## SB, Wrong belt pulley installed, K 970 RING 17", 2024-11

Fig. 1: Correct belt pulley for K970 RING 17", black with a diameter of 42,5 mm.

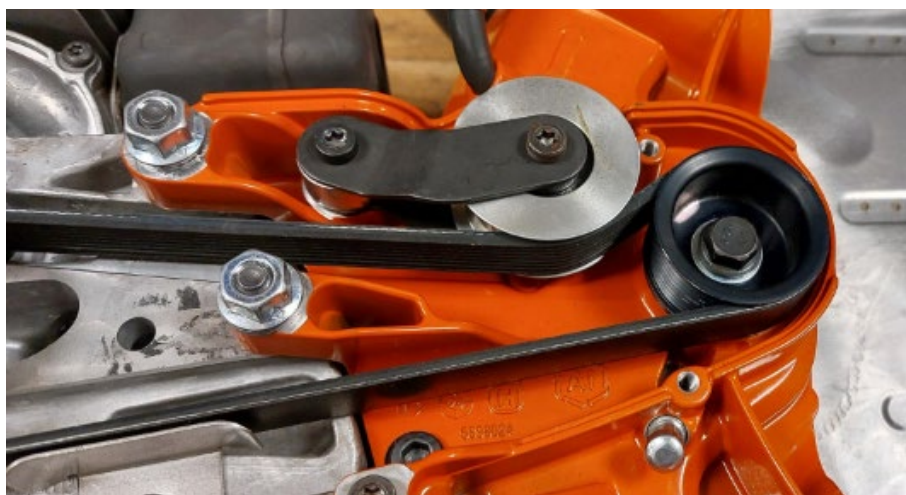
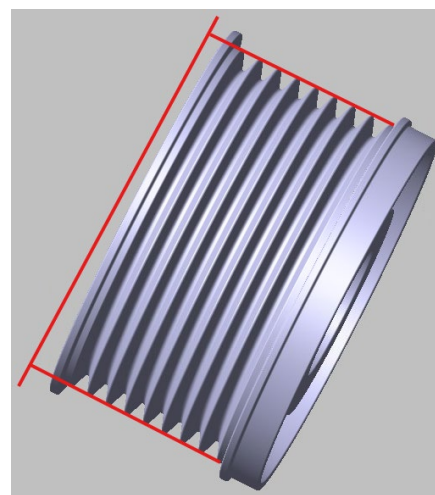
It has come to our attention that the wrong forward belt pulley was installed in a number of K970 RING 17" products. Due to unfortunate events, the belt pulley for K970 RING 14" was used instead of the correct one.

A typical symptom is that the belt seems to be too long and cannot be tightened with the belt tensioner.

**The correct belt pulley for K970 RING 17" is black and has a diameter of 42,5 mm on the PJ-profile as shown in figure 1. The pulley for 14" is of aluminium colour, smaller and measures 38,5mm, figure 2.**

Check the local stock of K970 RING 17" and make sure that the correct belt pulley is installed. Replace if necessary. If a customer reports issues with belt tensioning on a K970 RING 17", check that the correct pulley is installed.

Correct part no: 584271202.
